ACCESSION NBR: 8412270395. DOC. DATE: 84/12/19 NOTARIZED: NO DOCKET #  
 FACIL: 50-387 Susquehanna Steam Electric Station, Unit 1, Pennsylvania 05000387  
 AUTH. NAME: CURTIS, N.W. AUTHOR AFFILIATION: Pennsylvania Power & Light Co.  
 RECIP. NAME: SCHWENCER, A. RECIPIENT AFFILIATION: Licensing Branch 2

SUBJECT: Forwards Rev 1 to inservice insp program plan & response to 840912 request for addl info on program. Rev to program is result of addl relief requests identified & editorial changes deemed necessary. Fee paid.

SUSQUEHANNA STEAM ELECTRIC STATION  
REQUEST FOR ADDITIONAL INFORMATION  
ON UNIT 1 ISI RESPONSE & REVISION 1  
TO UNIT 1 ISI PROGRAM PLAN  
ER 100450 FILE 841-4 & 899  
PLA-2357

**FIGURE 1**

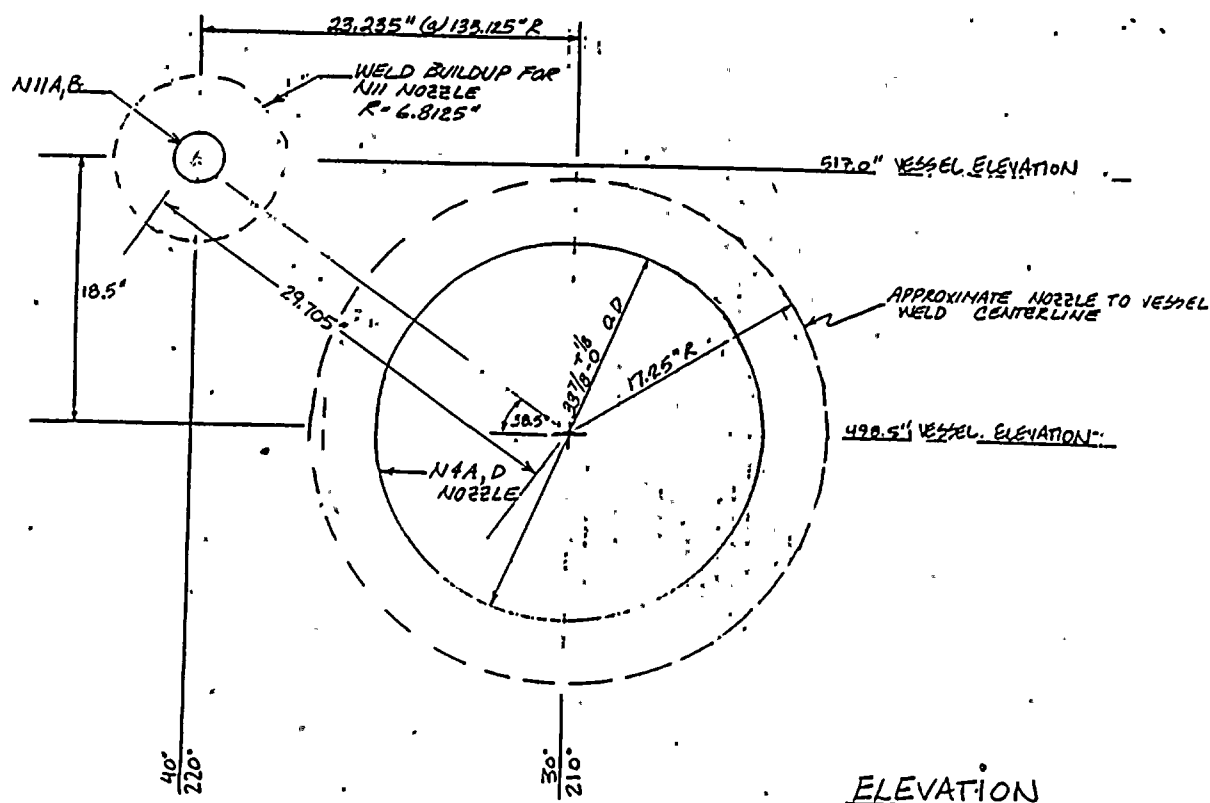
Please provide sketches of Nozzles N4A and N4D, showing dimensions and proximity to Nozzles N11A and N11B and a narrative description of the reason that full volumetric examination cannot be accomplished using a combination of automated and manual scanning techniques. Also indicate approximately what fraction of the 60-degree segment not covered by automatic inspection can adequately be covered by manual inspection.

Figure 1 illustrates the approximate dimensions/clearances for the N11A,B instrumentation nozzles to the N4A,D feedwater nozzles. Figure 2 illustrates the nozzle to vessel weld details and the 80 W 80 Section XI examination volume.

For a complete manual examination - 45° and 60° - available scan paths of approximately 11" and 15.5" from weld centerline, respectively, are necessary. Inadequate scan paths exist for both the 45° and 60° manual scans for approximately nine (9) inches (30°) of nozzle circumference. Given the available scan path, and allowing 11/16" and 7/8" - for 45° and 60° respectively-shoe to beam exist point distances, approximately 65% of the required volume cannot be examined using a 60° angle beam, while 35% cannot be examined using a 45° angle beam.

Due to the clearances required for the automated equipment, no examination can be performed for a full 60° segment of the weld. Depending on specific access provisions in each location, it is anticipated that 50-60% of the area missed by the automatic equipment may be manually examined. Actual coverage will be evaluated on completion of the initial manual exams.
